SOIL AND GEOLOGY STUDY

**Team Chris Subdivision
Black Squirrel Creek
El Paso County, Colorado**

JOB NO. 196369

September 13, 2024

SITE VICINITY MAP

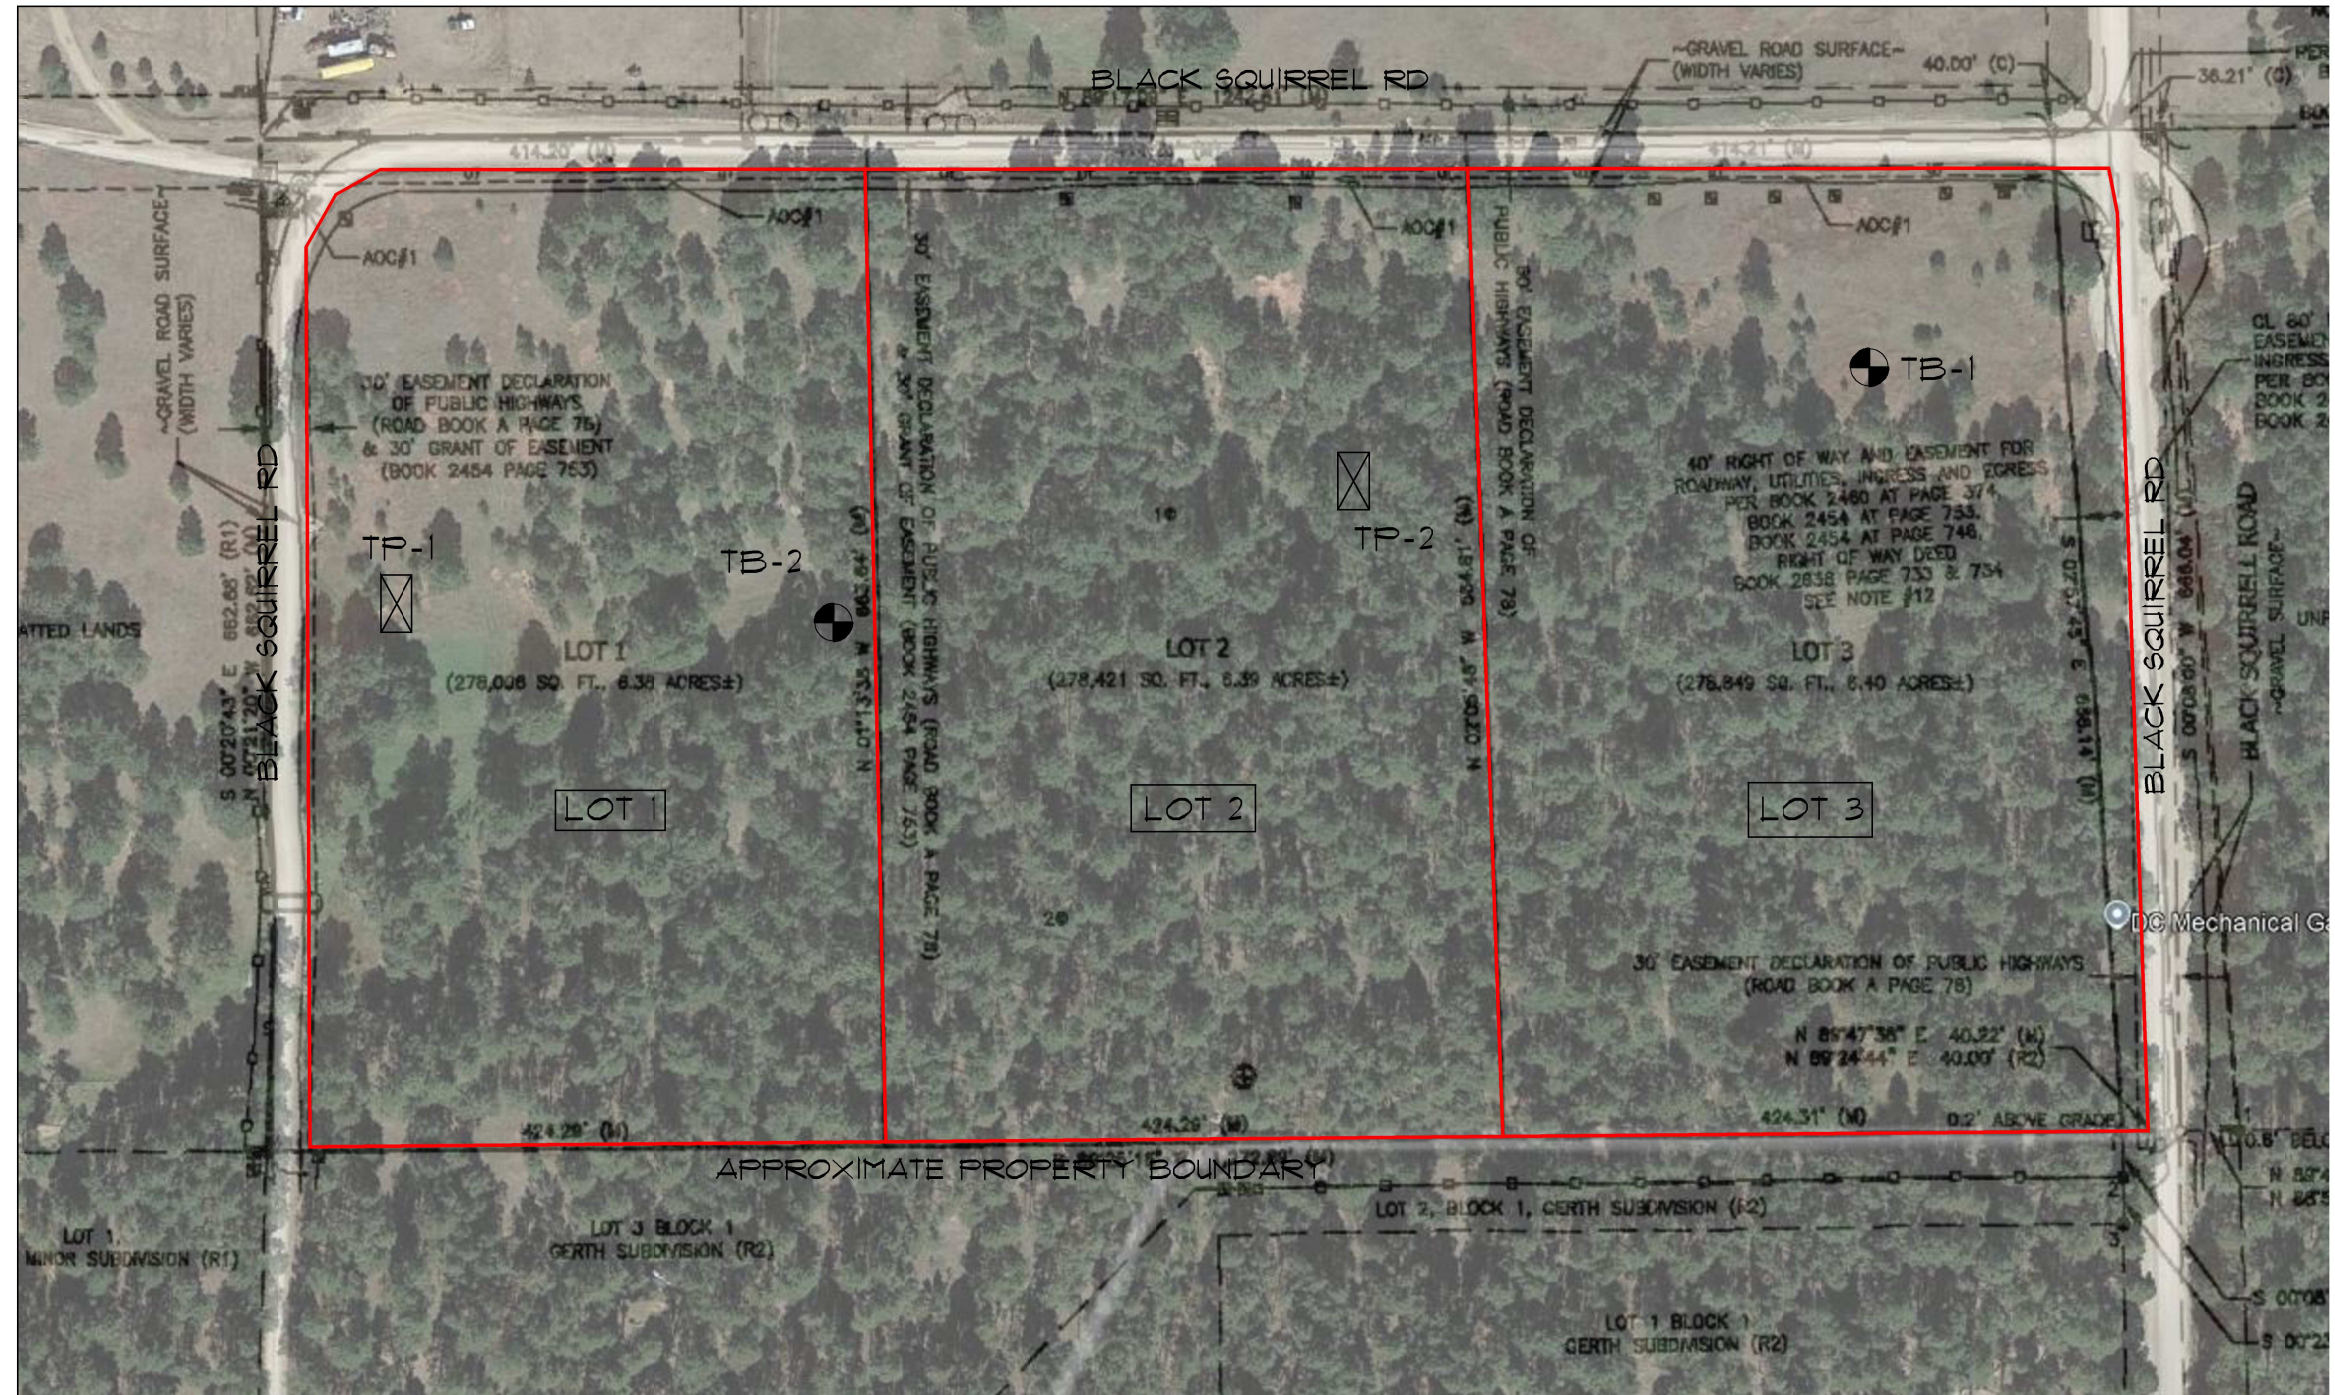
EPC database has the private road listed as Lil Squirrel Lane. Please update this throughout this report in both the written narrative and figures.
